Access Compliance Report Public Rights-of-Way (Curb Ramps)

Main Street: HAZARD_AVE		Cross Street: NEWLAND_ST		Location:	SE
ADA ID: RPAT220221145723	Ramp Type: Type 4 - Parallel	Initial Pass/Fail: Fail	Overall Compliance: No	Severity Score:	30

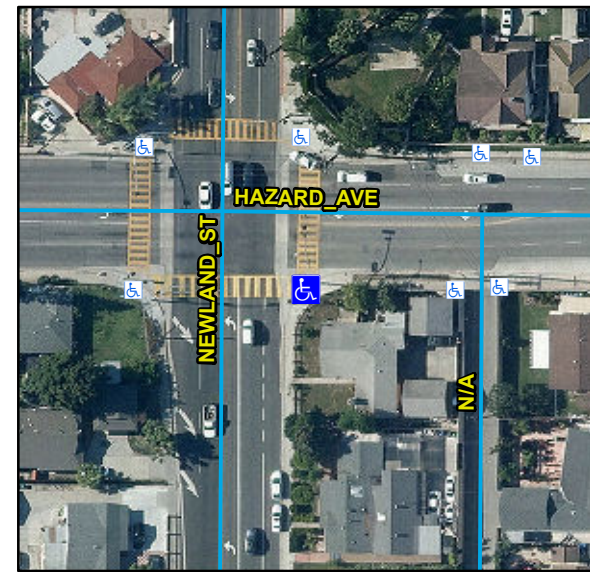
Compliance	Description	Data	Compliance	Description	Data
N/A	Ramp Length LT (in)	96	N/A	Ramp Length RT (in)	84
Yes	Ramp Width LT (in)	80	Yes	Ramp Width RT (in)	68
No	Ramp Run Slope LT (%)	8.5	Yes	Ramp Run Slope RT (%)	3.8
Yes	Ramp Cross Slope LT (%)	0.8	Yes	Ramp Cross Slope RT (%)	1.9
N/A	Landing Present	N/A	N/A	DWS Provided	N/A
N/A	Landing Length (in)	N/A	N/A	DWS Contrast	N/A
N/A	Landing Width (in)	N/A	N/A	DWS Length (in)	N/A
N/A	Landing Run Slope (%)	N/A	N/A	DWS Full Width	N/A
N/A	Landing Cross Slope (%)	N/A		DWS Offset Type	N/A
N/A	Landing Movement Obstructed?	N/A	N/A	DWS Offset Left (in)	N/A
	Landing Movement Type	N/A	N/A	DWS Offset Right (in)	N/A
N/A	Landing Shared	N/A			
N/A	Clear Space	Yes			
N/A	Clear Space To Crosswalk (in)	48			
N/A	Marked Crosswalk 1	Yes	N/A	Marked Crosswalk 2	Yes
	Crossing 1 Direction	N		Crossing 2 Direction	W
	Marked Crosswalk 1 Width (in)	132		Marked Crosswalk 2 Width (in)	132

Remove & Replace Curb Ramp With Two New Directional Ramps or Equivalent.

R304.3.2, R302.7, STD 1115
